File no. PM00301.04

Hume Highway upgrade. Woomargama bypass (MP 08_0237). Modification request for Mountain Creek Bridge flooding impacts.

Letter dated 11 April 2011 from the Environment & Sustainability Manager – HHWA

Mountain Creek – Hydrographs at different chainages

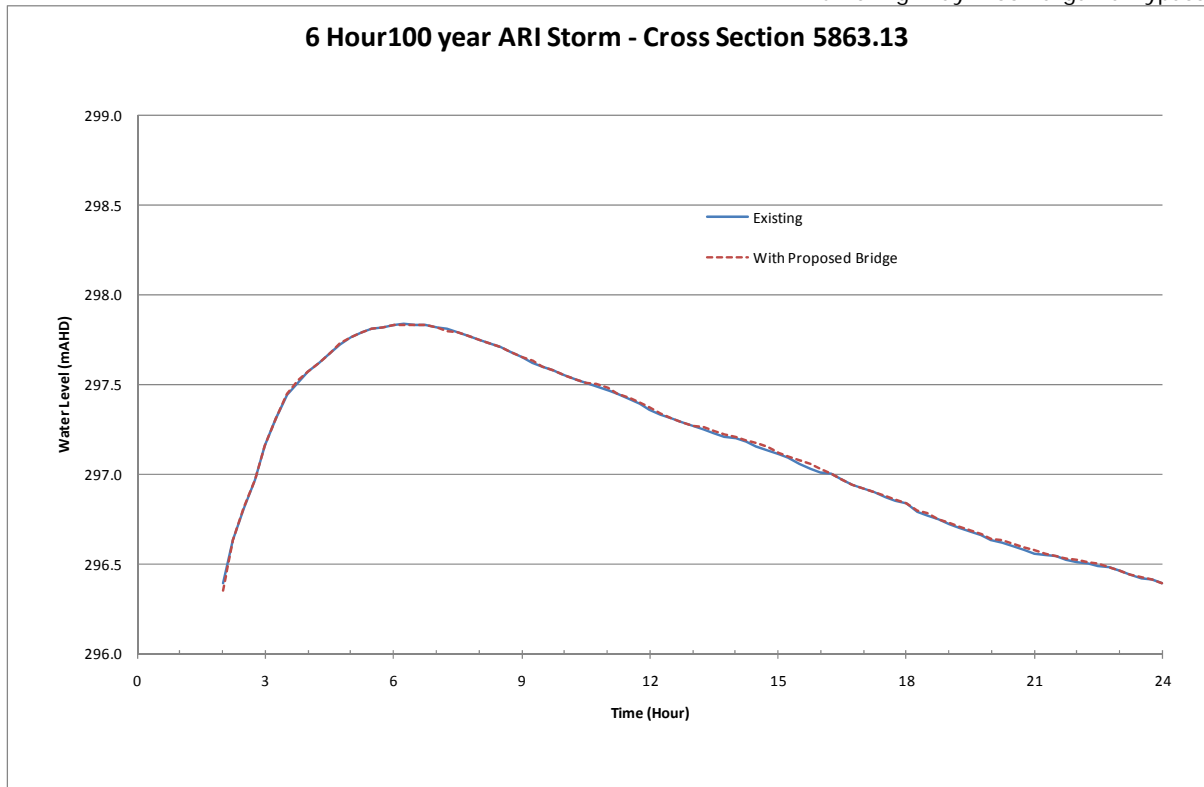
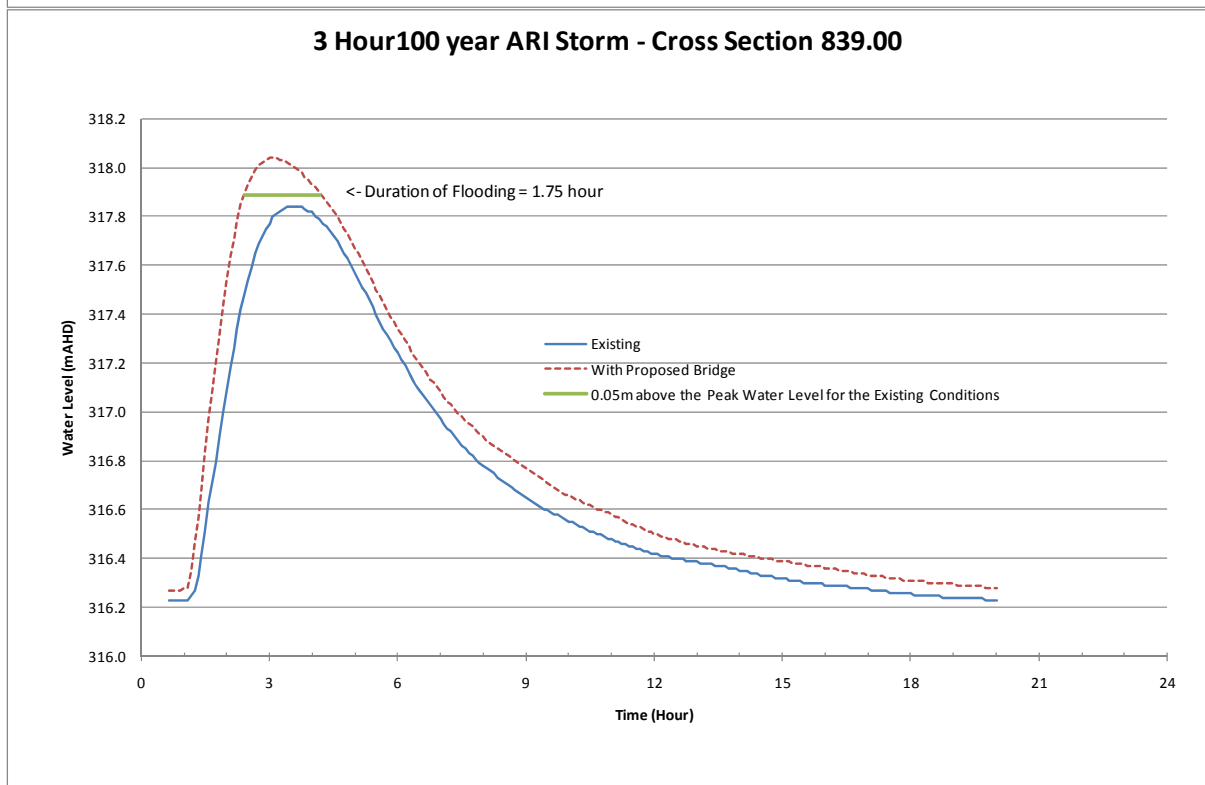
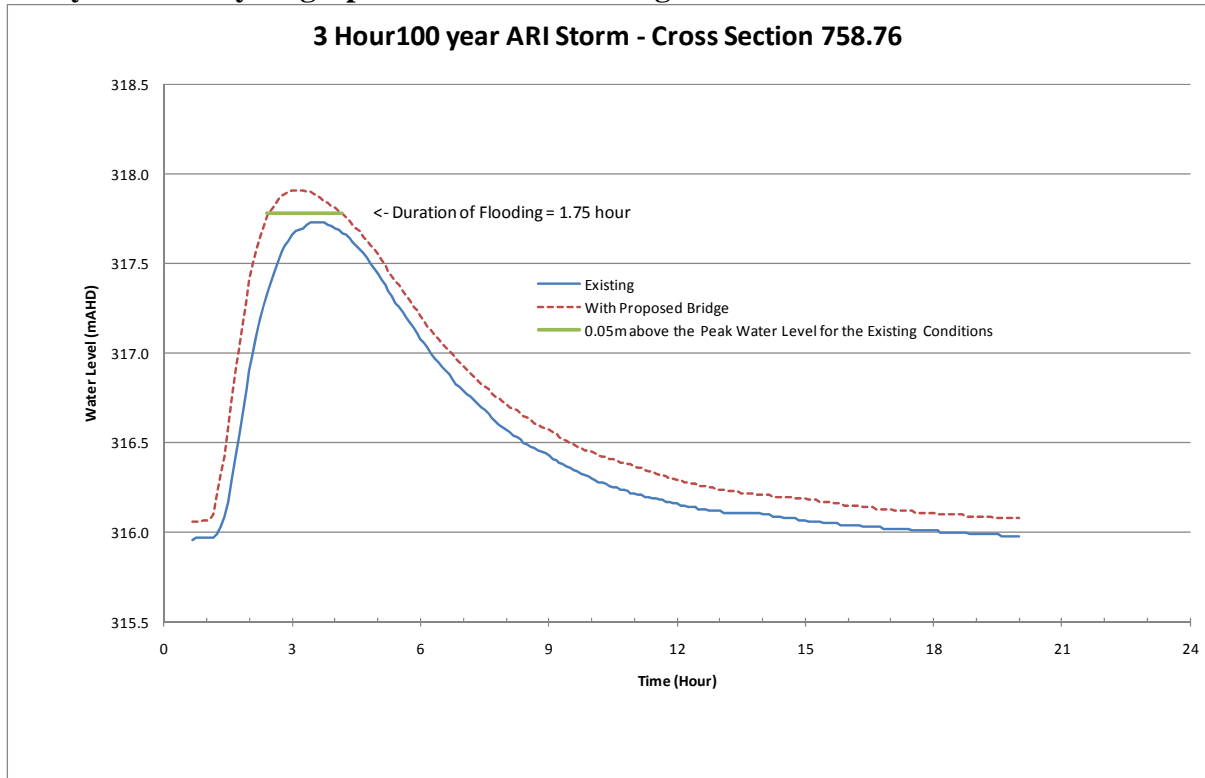
In relation to the time criterion of 1 hour, it has been interpreted that this is the time period which the existing 1 in 100 year flood extent is exceeded. Hydrographs for a number of key locations along Mountain Creek are attached. Near the bridge where flood levels and extents increase, the time period which the existing 1 in 100 year flood extent is exceeded would be about 6 hours. However about 600m upstream of the bridge (ch 5863.13), the hydrographs of the existing and 4 span bridges are identical indicating there would be no change in the time extent of flooding (or 0 hours).

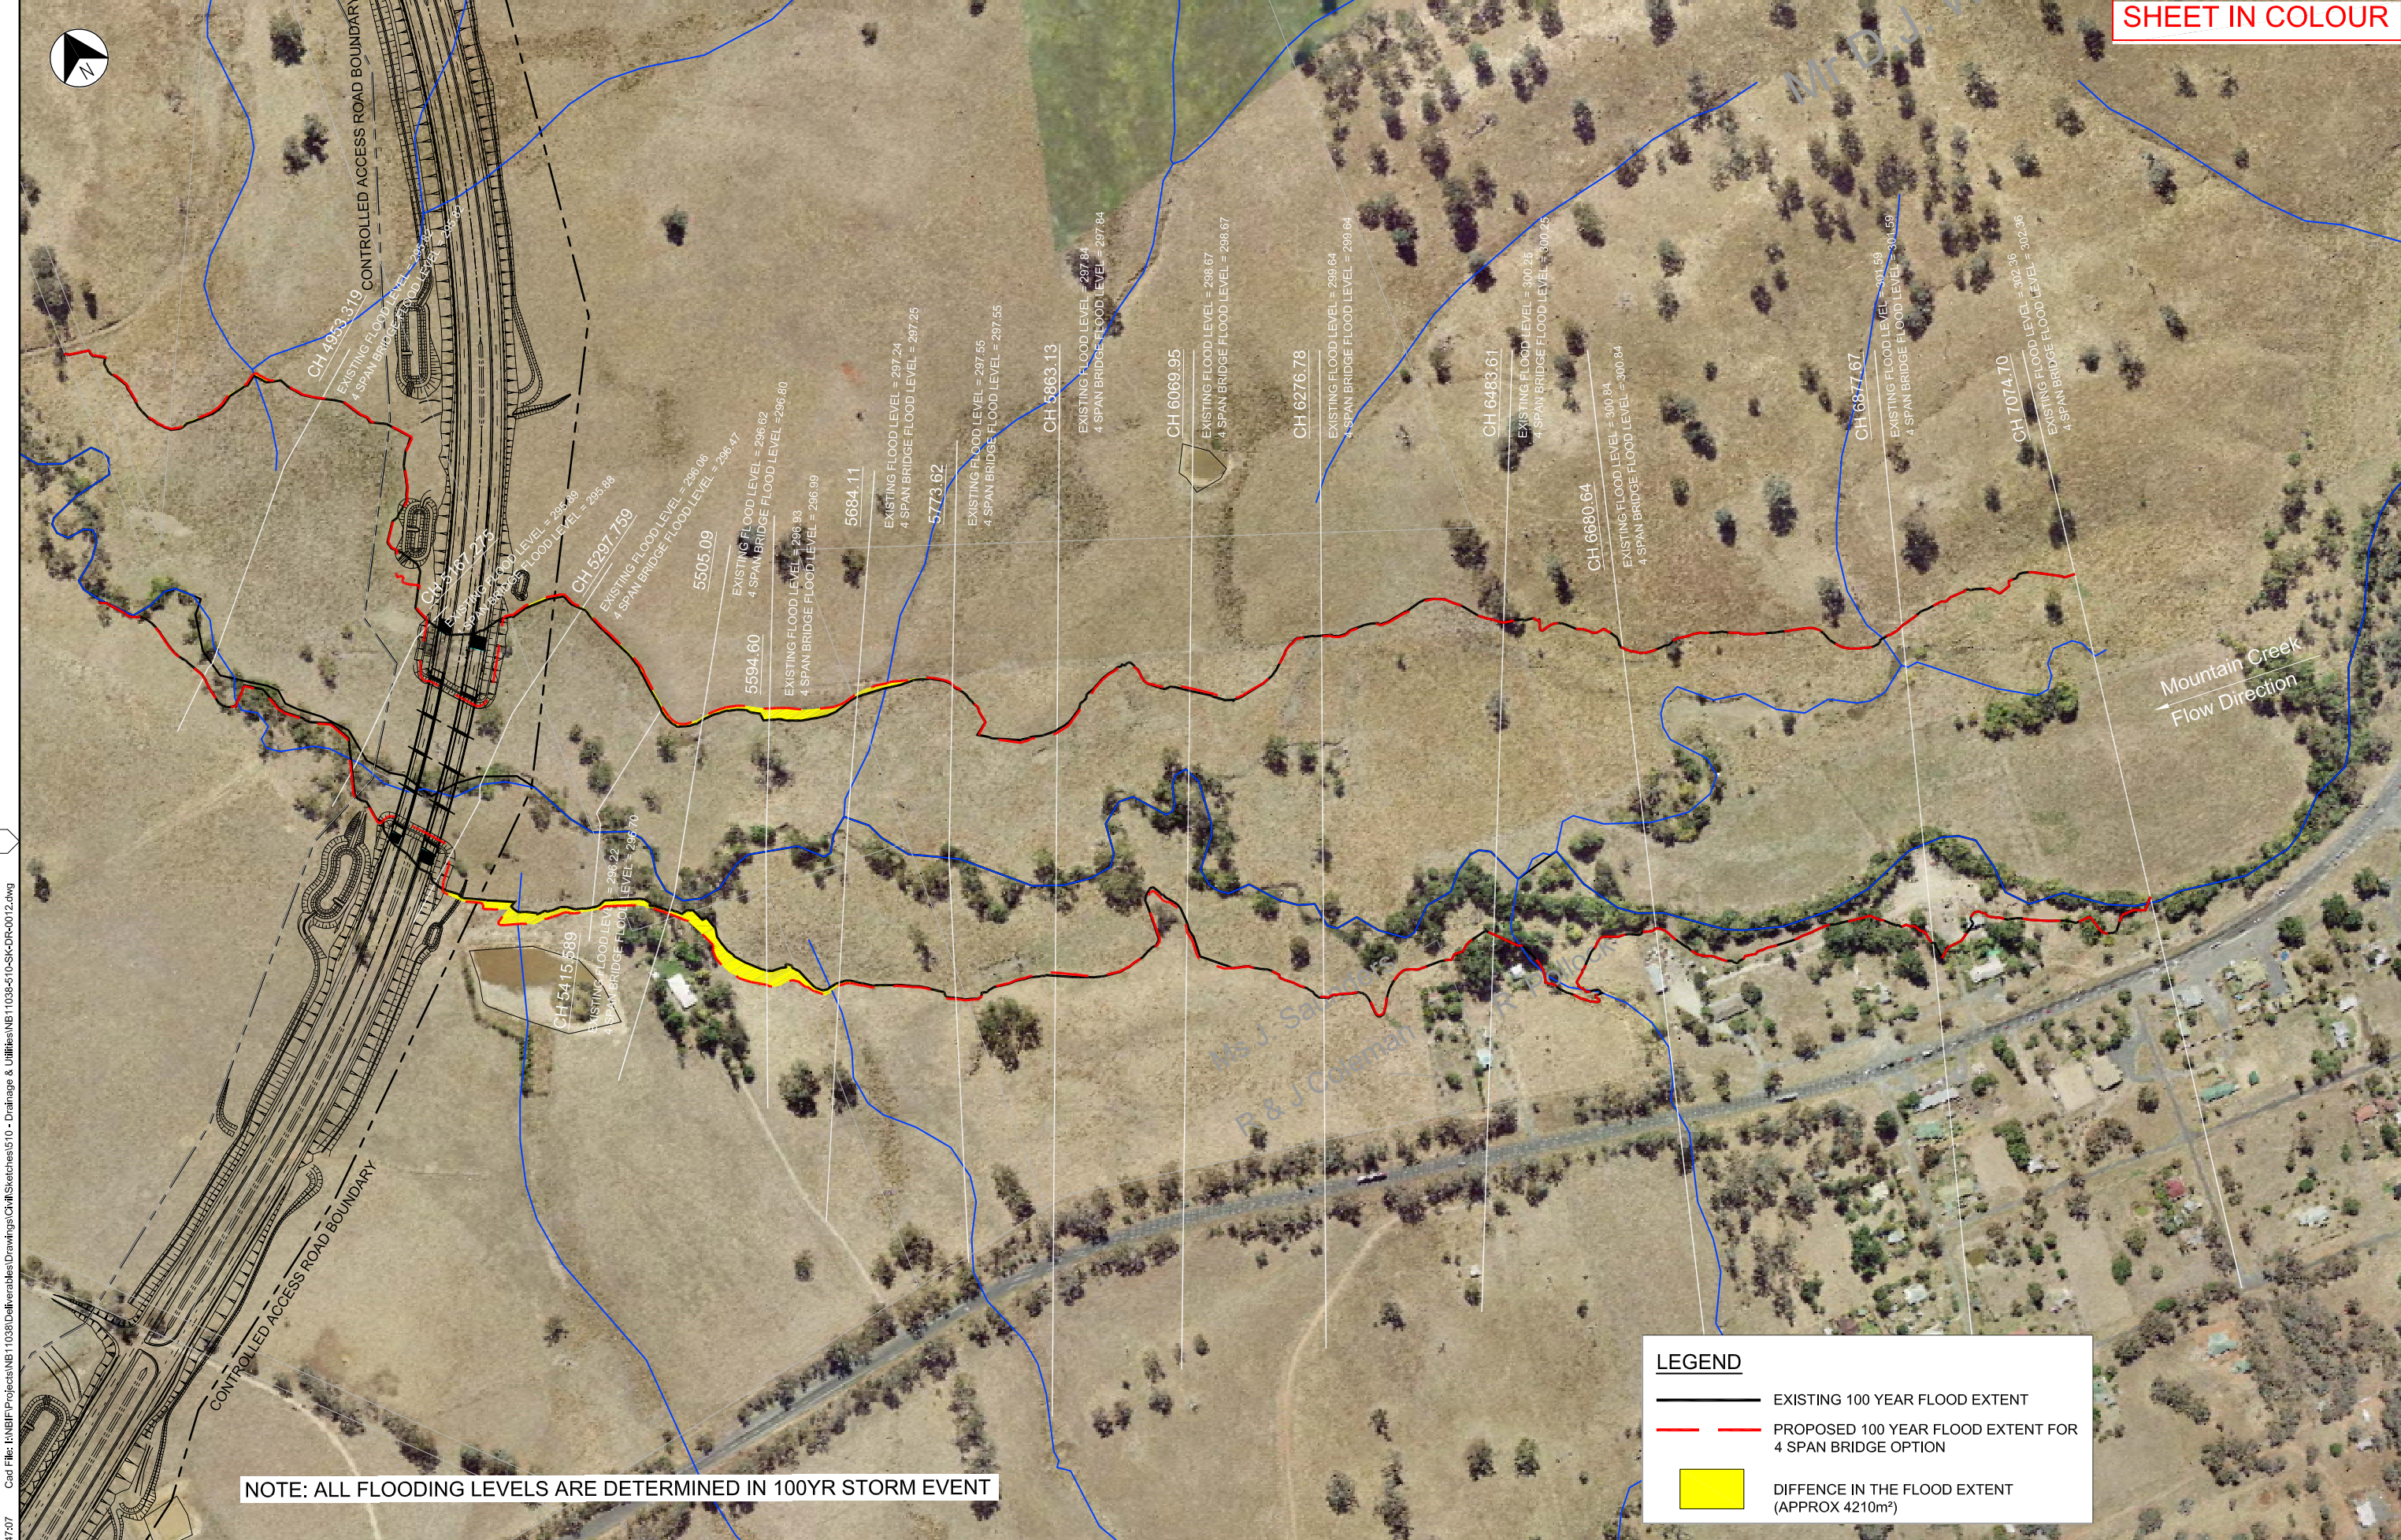
Based upon the modelling, increases in the 100 year flooding extents in Mountain Creek would be limited to approximately 500m upstream of the bridges within RTA owned land and would range up to 0.48m (See **NB11038-510-SK-DR-00012**). This reach of Mountain Creek is characterised by a low flow channel and wider defined floodplain (See **Photo 2-2, Technical Paper 3 - EA**). High flows such as encountered in 100 year flow events, would result in the low flow channel being overtopped and flows spreading into the floodplain. However at all locations within 500m upstream of the bridges, 100 year flows would be contained within the Mountain Creek floodplain and would not impact upon any buildings or other infrastructure. At the location where the increase in 100 year flood level was the greatest (200m upstream of the bridges), the width of flow contained the floodplain in a 100 year event would increase from 180m to 190m (approx 5% increase), which is not significant. The greatest

increase in the width of the flood extent would be 25m approximately 300m upstream of the bridge – but again would be contained within the floodplain. No houses or private land owned land upstream of the bridge or in the village of Woomargama would be affected by an increased flooding extent (ie the increase is 0mm).

Drawing No. NBI 1038-510-SK-DR-0006 Rev E

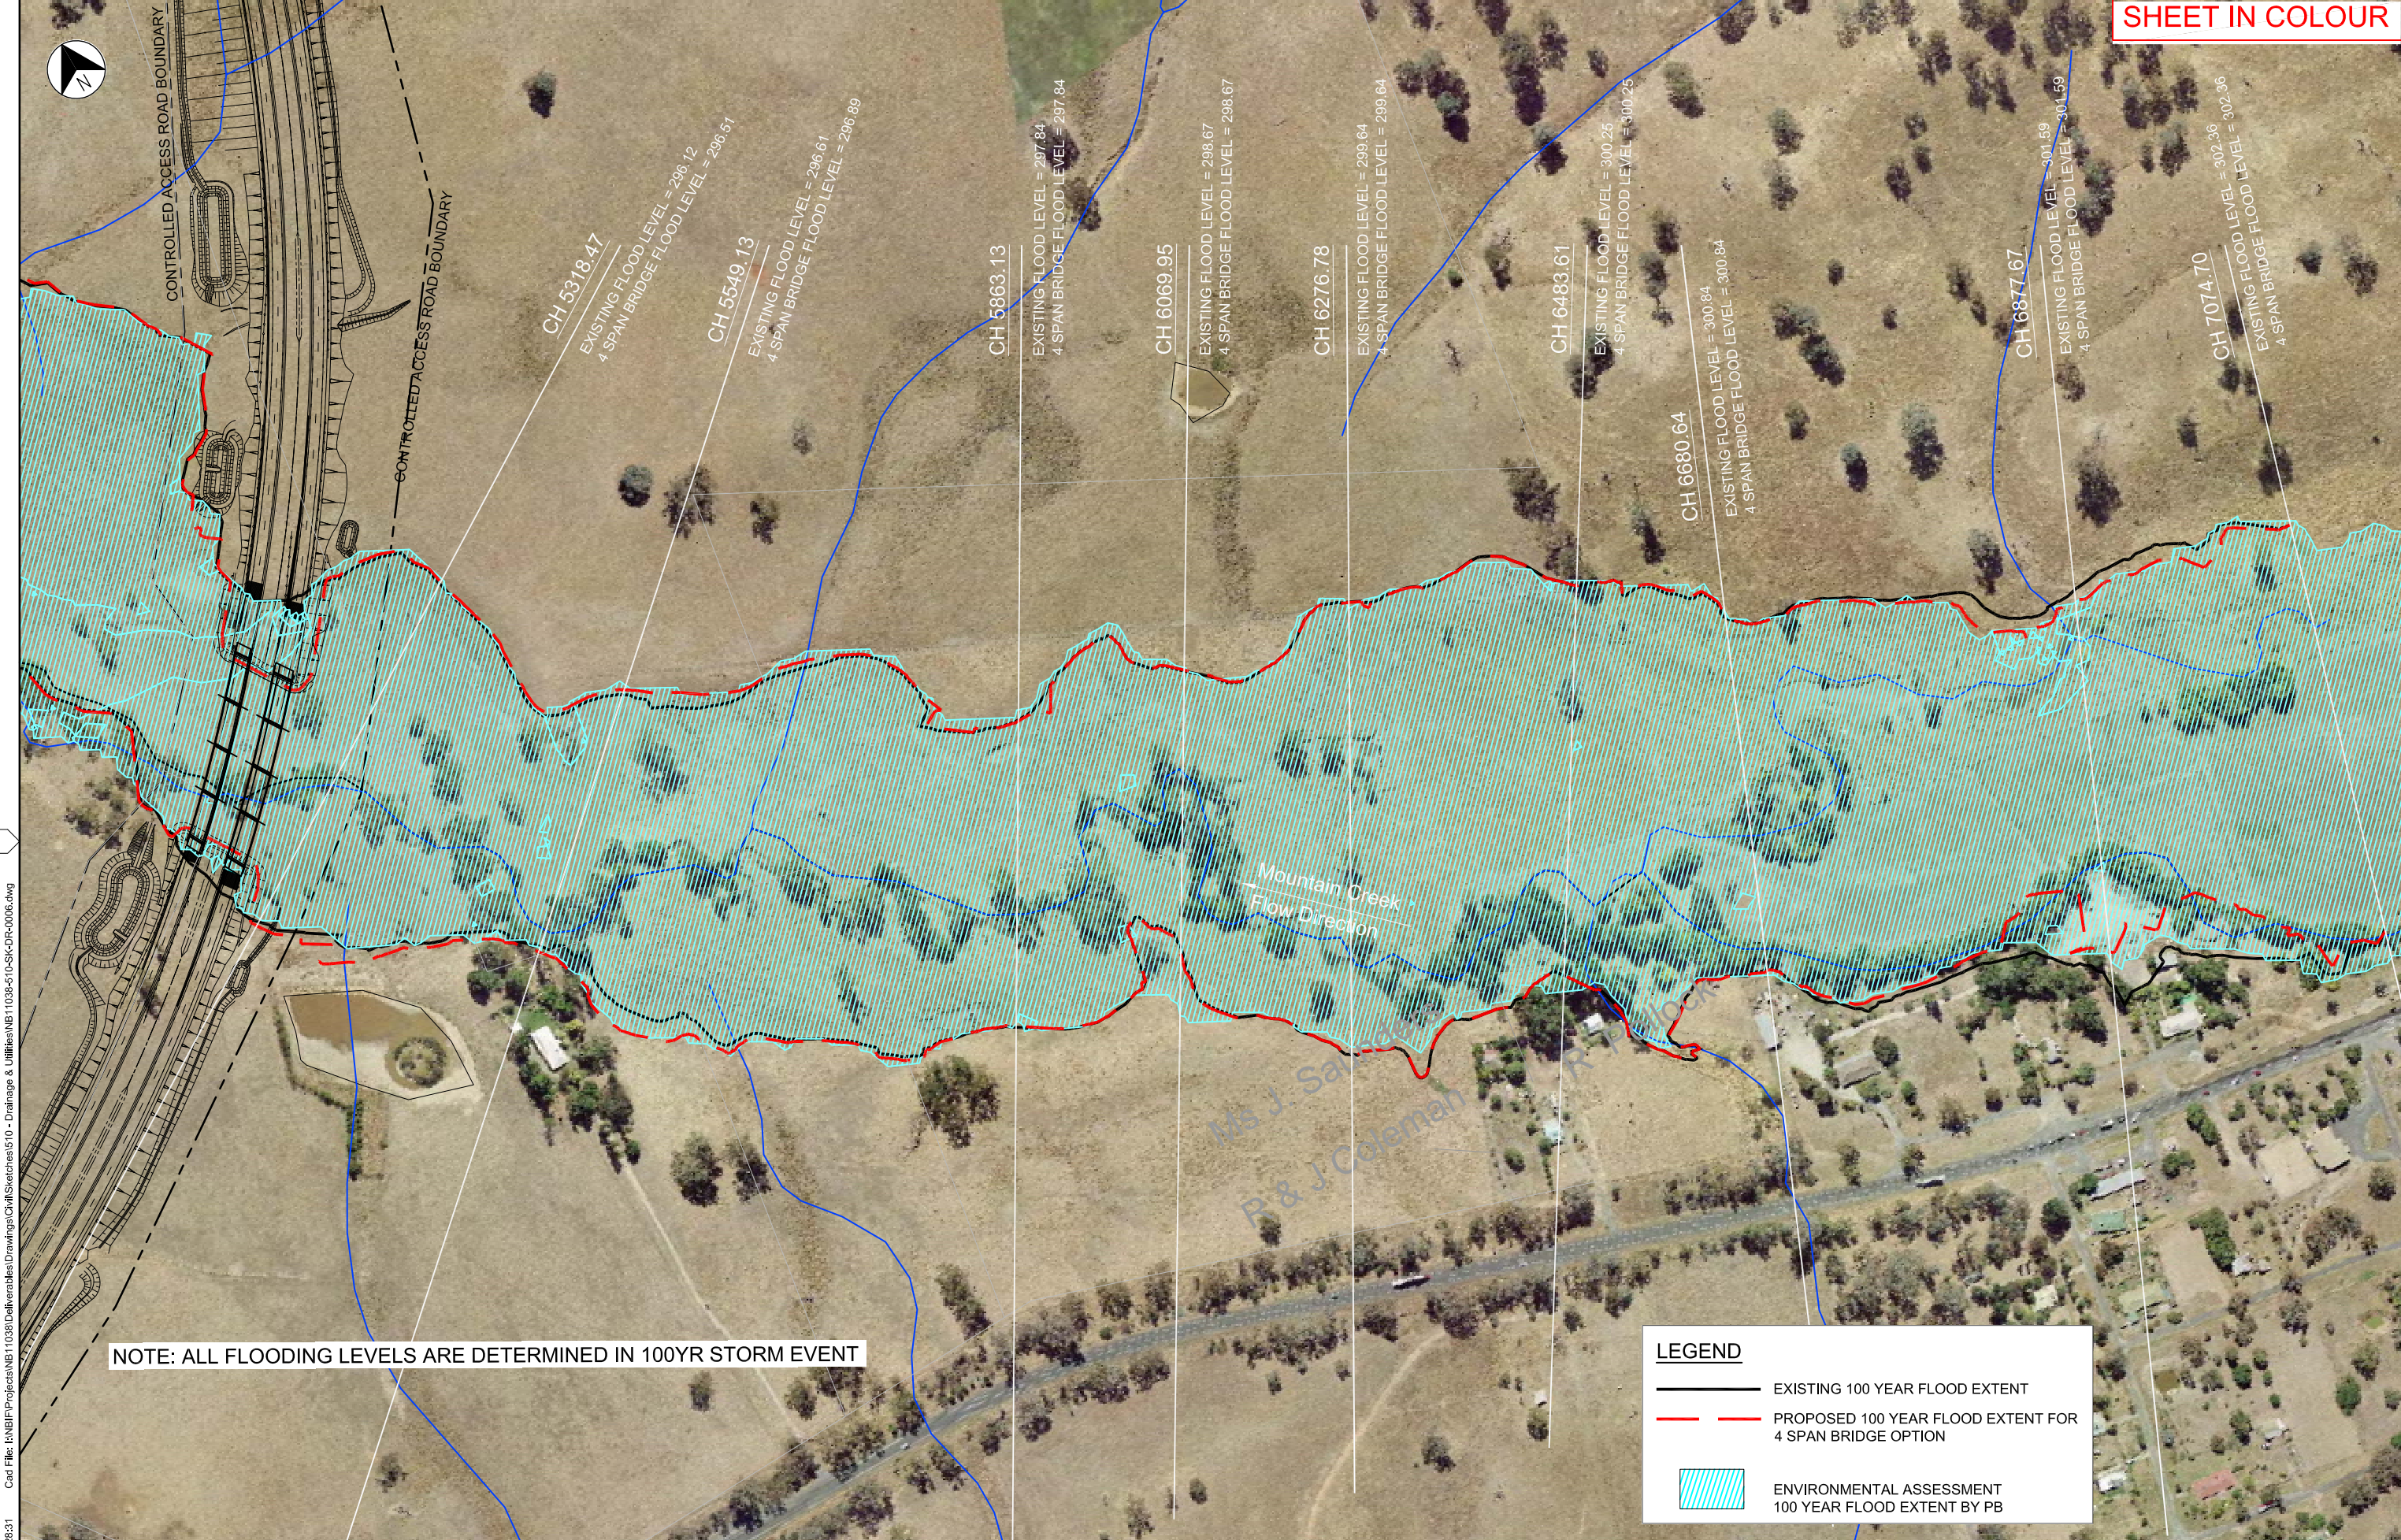
Accordingly, in accordance with section 75W(2) of the *Environmental Planning and Assessment Act 1979* the RTA requests the Minister to modify the approval to allow construction of twin 128 metre four span bridges at Mountain Creek with modelled flooding impacts as shown on sketch NBI 10038-510-SK-DR-0006 Rev E.

- Detailed design gave consideration to various bridge options of three, four and five span bridges. The potential flooding impacts of these options are shown on drawing number NBI 1038-SK-DR-0006. All options had afflux in excess of the design criteria proposed in the EA but were limited to a maximum distance of approximately 600 metres upstream from the bridges.
- The proposed four span bridge results in a maximum afflux of 480mm approximately 200 metres upstream reducing to zero at approximately 500 metres upstream. The flooding impacts remain wholly contained within the floodplain. At the location where afflux is greatest the width of the flow would marginally increase from 180 metres to 190 metres and the greatest increase in width of flow would be 25 metres at approximately 300 metres upstream.

2.26A Notwithstanding conditions 2.25 and 2.26 the detailed design of the new Hume Highway Bridges at Mountain Creek shall limit to the greatest extent practicable, increases in flooding impacts between the bridges and a point 600 metres upstream of the bridges to those shown on Drawing No. NBI 1038-SK-DR-0006 Rev E
